Multiple Sewershed Package 15: CIPP Project
Solicitation No. CO-00654
Job No.: 23-4507

ADDENDUM NO. 2
October 10, 2023

RESPONSES TO QUESTIONS

**I-35 & WHIRLWIND DR.
SEWER PLAN VIEW
STA 4+00 TO STA 8+00
SHEET 1 OF 4**

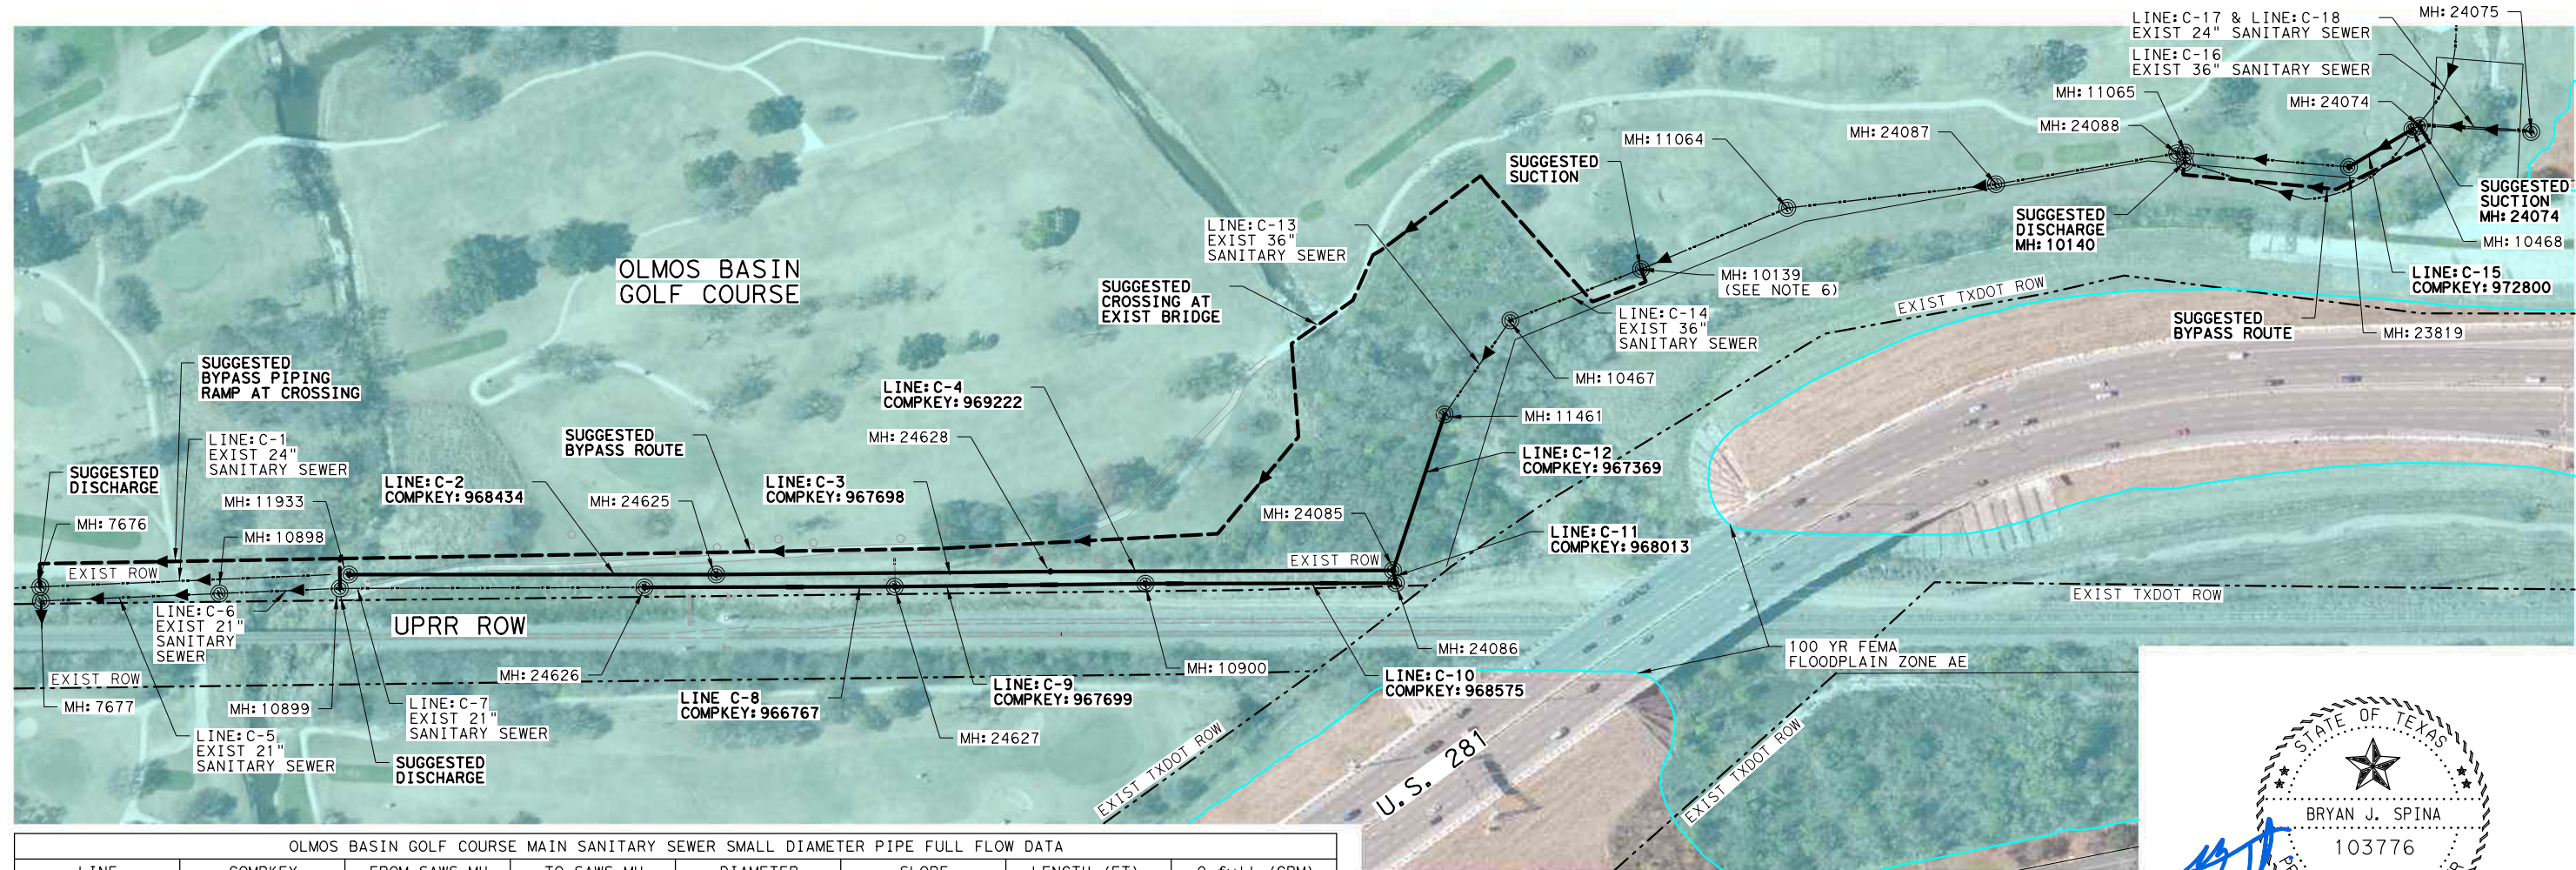
6. **Question: Can the Ground Elevations and Invert Elevations be provided for MH's 51284, 11461, 24086, 10900, 24627, 24626, 20125, 3989686, 19170, 1154761, 3989679, 34953?**

Response: The plan sheets have been updated and included with this addendum to include the top of manhole elevation and inverts at all tie-in manholes for information purposes.

S20

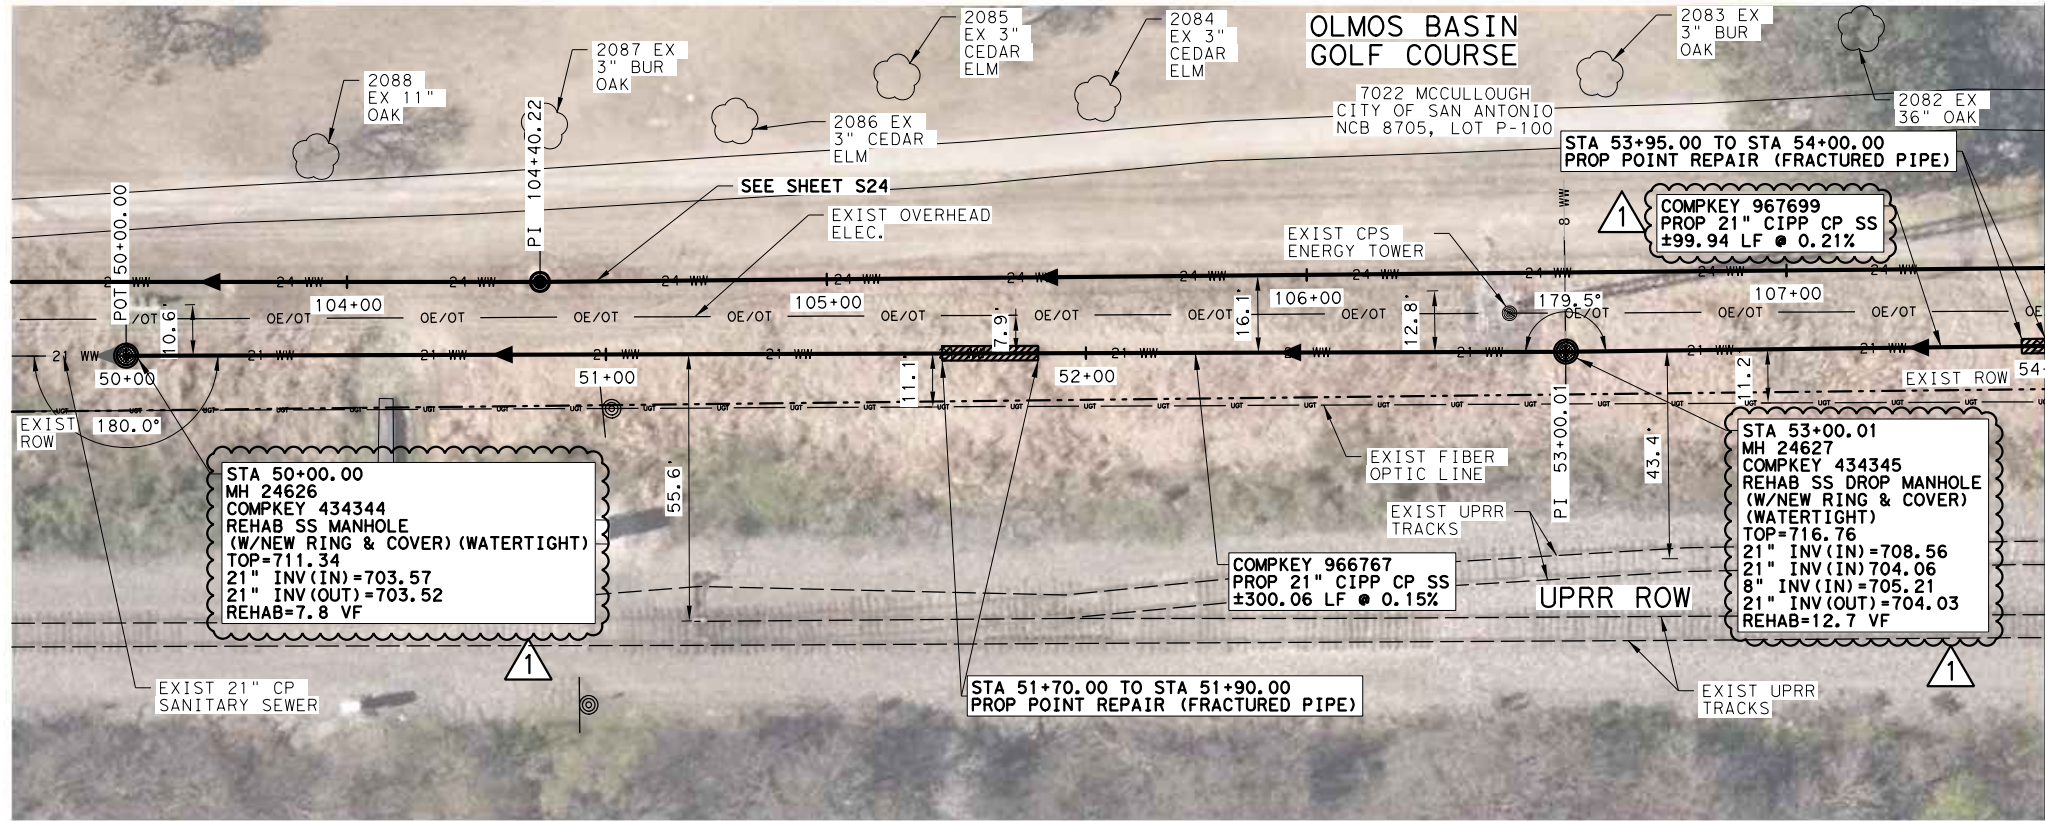
1. **Remove and replace Page S20 of Plan Set 1 of 2 with the page dated 10/3/2023 that updates the Olmos Basic Golf Course contact.**
2. **Remove and replace Pages S15, S27, S29, S35, S36, and S38 of Plan Set 1 of 2 with the page dated 10/5/2023 that provides top of manhole elevations and invert elevations for tie-in manholes.**

OLMOS BASIN SEWER PLAN VIEW
 STA 50+00 TO STA 54+00
 SHEET 5 OF 9

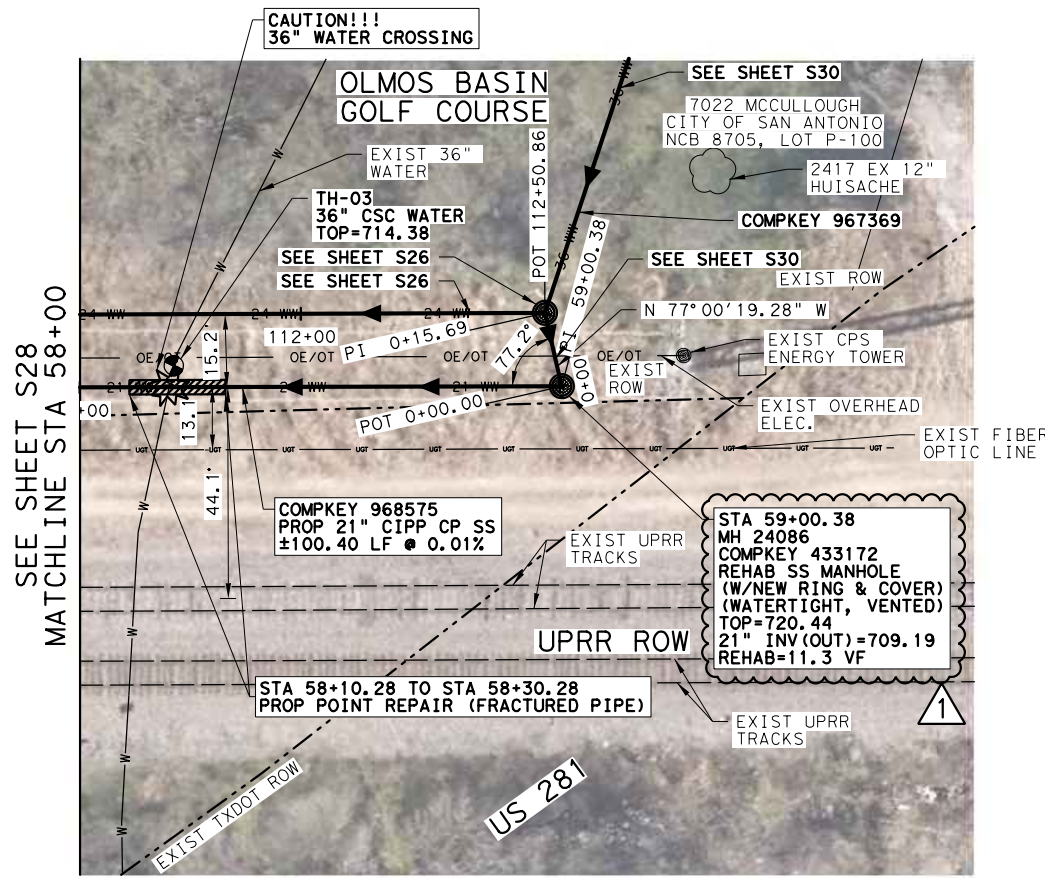
7. **Question: Segment 10900 to 24627 is called out for CIPP on Sheet S28 and also called out for Pipebursting on S27. Can you please clarify?**

Response: Sheet S27 has been updated to note the pipe to be rehabbed via CIPP as shown on Sheet S28.
